Tennessee Avenue Beer Garden

Bulk Variance Application & Revised Site Plan

Review Letter #1

Block 54, Lots 13 and 15 133 South Tennessee Avenue

View of Outdoor Bar and Principal Structure Looking North

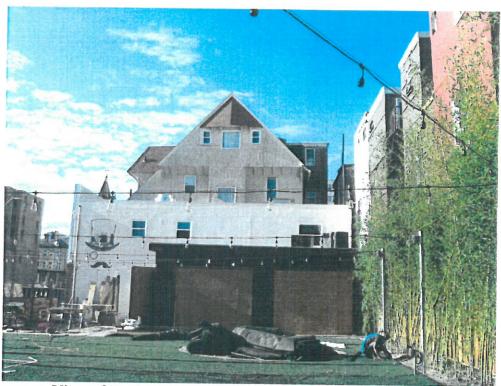
- 1. The outdoor bar is located one foot (1') from the rear property line. As noted above a roof has been added to the bar, thusly it is considered a structure and is bound to the setback requirements of the zone. The required rear yard setback in the RC Zone is 20 feet, as per Section 19:66-5.10(a)(iv)(10) of the CRDA Tourism District Land Development Rules. A variance is required.
- 2. A 7' high fence is proposed at the front right (southwest) corner of the building, in order to screen and provide access to the utility meters. Section 19:66-7.7(a)(1) of the Land Development Rules prohibits fences in the front yards in the RC Zone A variance is required.

- 4. The Applicant shall seek approval from the City Building Code Official and the Fire Marshal for the construction of the roofed outdoor bar structure.
